# Bulletin

CSB-1389-2  
Country : UK  
Date : 7/10/2007  
APC : ALL  
Repair Level : 2

Subject GSM- V3\_05 CR-Differences between V3\_05 and V3\_06  
Model Effected V3\_05 & V3\_06

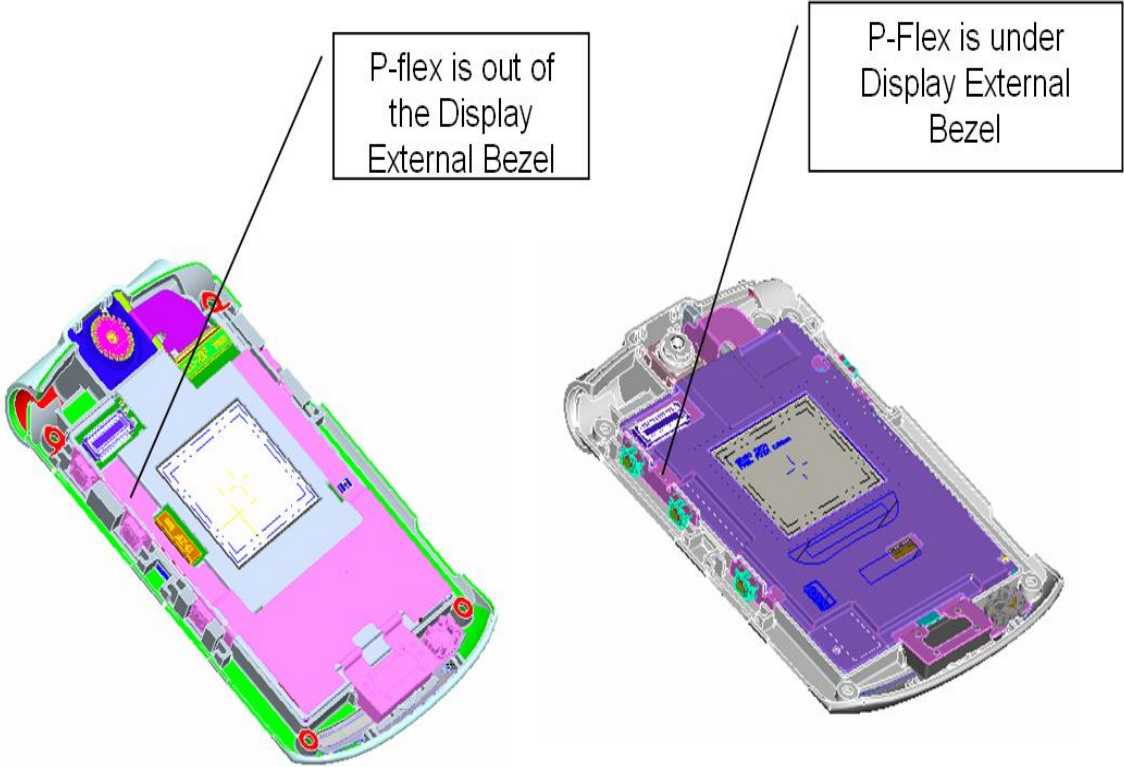
V3\_05 Battery Door

V3\_06 Battery Door

(Flip with hole)

(Metal)

(Plastic)

## Change of LCD module and FPC

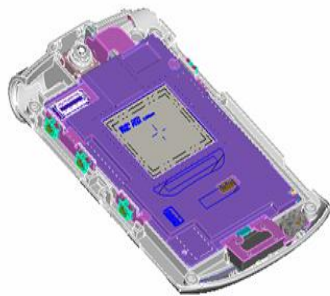
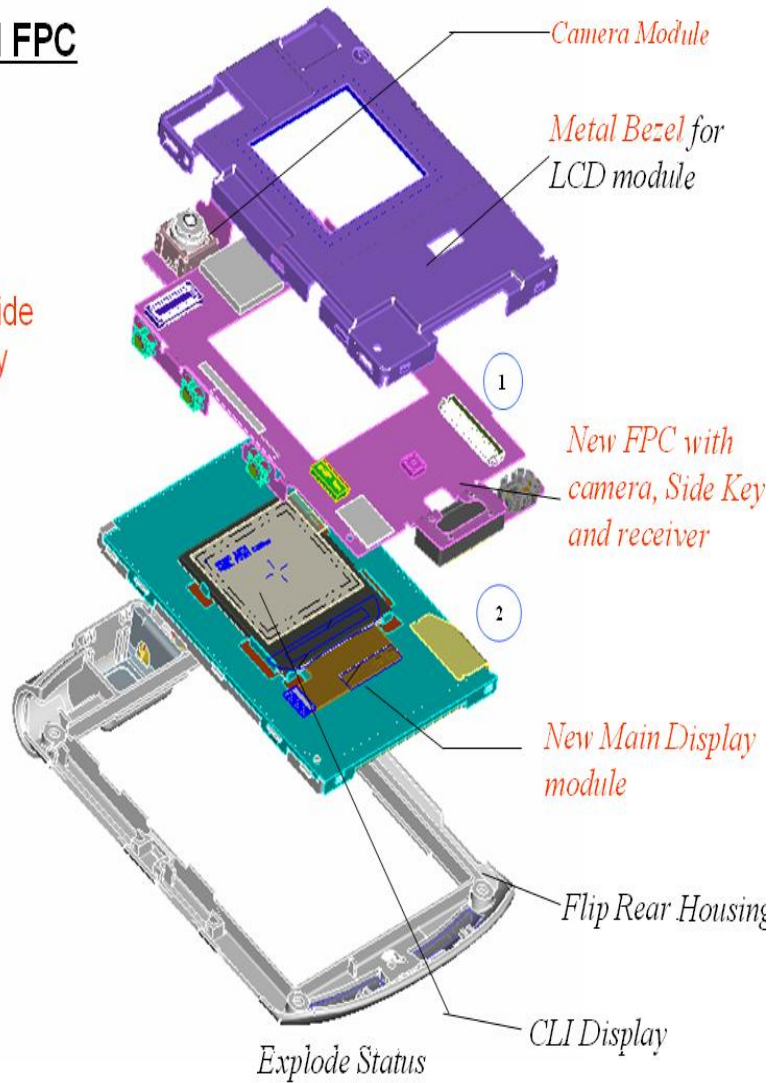
(The parts write by red are re-designed. )

- Combine the Camera FPC, Side key FPC and the Main Display FPC into to one new FPC;
- Modify the Metal Bezel.

## Change of Antenna Rear Assembly:

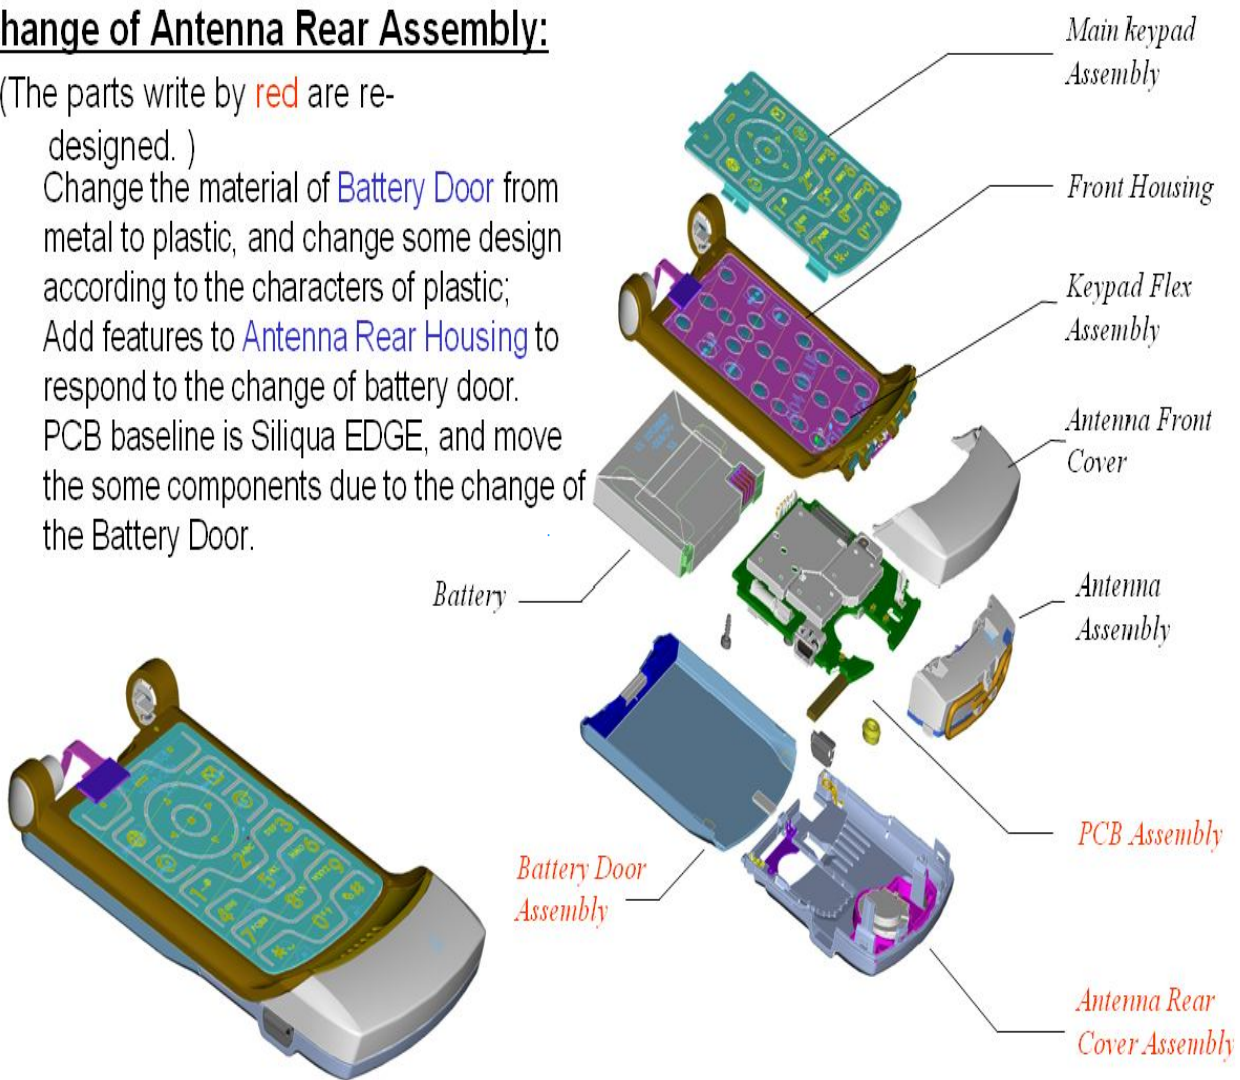
(The parts write by **red** are re-designed. )

- Change the material of **Battery Door** from metal to plastic, and change some design according to the characters of plastic;
- Add features to **Antenna Rear Housing** to respond to the change of battery door.
- PCB baseline is Siliqua EDGE, and move the some components due to the change of the Battery Door.
